SYMBOLOGY CONFIGURATION MANAGEMENT CHANGE PROPOSAL FORM			
CHANGE PROPOSAL NUMBER		MIL98-06	
ORIGINATOR	SPONSOR	DATE RECEIVED	DATE OF ACTION
COS/DOOCD	USAF	1 DEC 1998	3 FEB 1999
CHANGE PROPOSAL TITLE

CHANGE DESIGNATOR FOR SPECIAL OPERATIONS FORCES

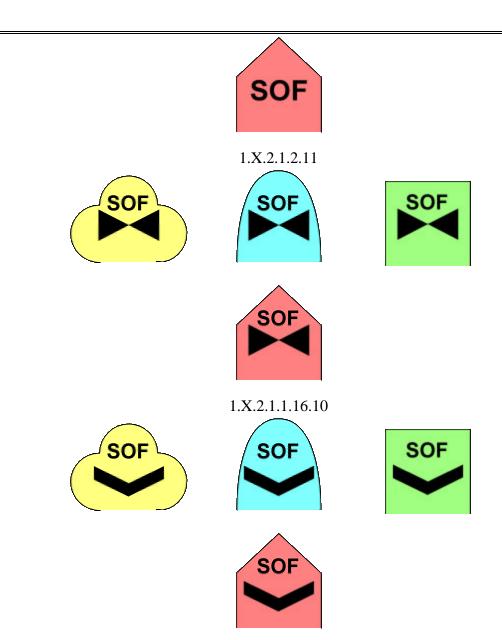
Change designator for Air Track Special Operations Forces icon to read "SOF" vice "M" on hierarchy numbers 1.X.2.1.1.18 and 1.X.2.1.2.11.

"SOF" is more readily associated with Special Forces.

CP MIL 98-06 proposed that the designator for Air Track Special Operations Forces be changed from the current "M" to "SOF" in hierarchy numbers 1.X.2.1.1.18 and 1.X.2.1.2.11. Justification for this change is that SOF is more readily associated with Special Operations Forces, and it will avoid confusion for the Warfighter. This change would also align the designators for Special Operations Forces between the Air Track and the Ground Track, which uses SOF in all instances to denote Special Operations Forces. Specifically, within the entire 1.X.6 hierarchy, SOF is used to designate nearly every SOF unit type, with only a few utilizing more specific codes in its place.

Recommend that this change be approved. The following changes must be made to the standard to incorporate the proposed changes:

- 1. Revise Appendix A, Table A-V, C2 Symbology: UEI symbol ID codes air for 1.X.2.1.1.18, 1.X.2.1.2.11, and (proposed) 1.X.2.1.1.16.10.
- 2. Revise Appendix A, Table A-XII, C2 Symbology: UEI set air to include four versions for 1.X.2.1.1.18, 1.X.2.1.2.11, and (proposed) 1.X.2.1.1.16.10.

Change Proposal was approved at the 3 February 1999 SSMC.
